QUALITY ASSURANCE -- NON-CONFORMANCE REPORT

Location: Changxing Island, Shanghai, P.R. China **Report No:** NCR-000442
Prime Contractor: American Bridge/Fluor Enterprises, a JV **Date:** 24-Sep-2009
Submitting Contractor: Zhenhua Port Machinery Company, Ltd (ZPMC), Changxing Island **NCR #:** ZPMC-0416

Reference Description: Vertical Weld in a Downward Progression in Crossbeam 8 and 12

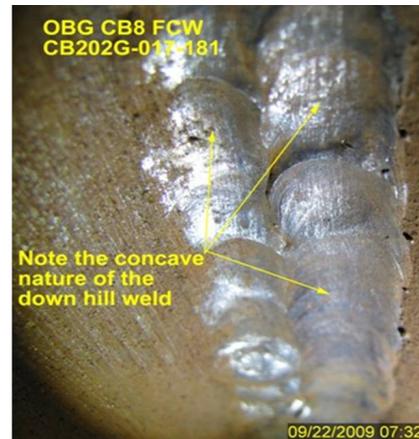
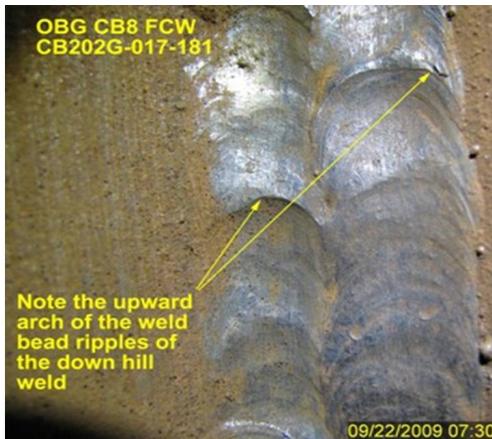
During random in process Visual Inspection (VT) of Fracture Critical Weld (FCW) at Crossbeam CB8, the Quality Assurance (QA) Inspector observed that ZPMC welding personnel have performed a vertical weld in a downward progression. The weld exhibits typical visual characteristics of a weld performed in a downward progression. This weld is identified as a FCW weld on the approved drawings. This weld ID is CB202G-017-181.

ZPMC QC confirmed that down hand welding was performed in locations identified in the NCR. ZPMC QC has generated a CWR to remove the down hand welds and replace the weld in conformance with the applicable WPS. A CWR for the weld in CB8 has been approved by Caltrans, and CWR for the weld in CB12 is currently being processed. ZPMC requests closure of this NCR.

ZPMC removed the welds in question and performed the new welds in conformance with the approved WPS.

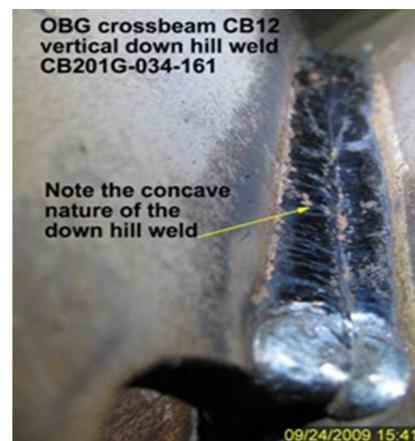
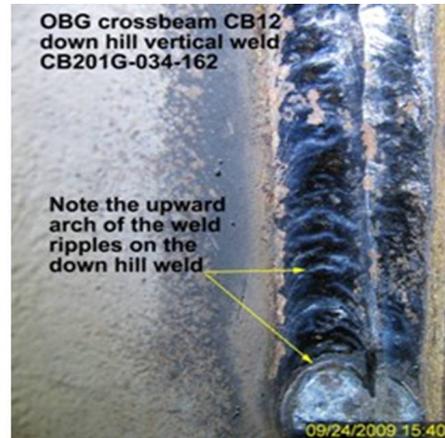
During random in process Visual Testing (VT) of Crossbeam CB 12. The Quality Assurance Inspector (QA) observed that the contractors welding personnel appears to have performed seven (7) vertical weld repairs in a downward progression. These repair welds appeared to exhibit typical visual characteristics of a weld performed in a downward progression. The affected welds are identified as CB201G-034-161, CB201G-035-143, 161, 145 and CB201G-036-163.

AWS D1.5 2002 section 4.6.8 "The progression for all passes in the vertical position shall be upward, unless a downward progression is qualified by tests approved by the Engineer".
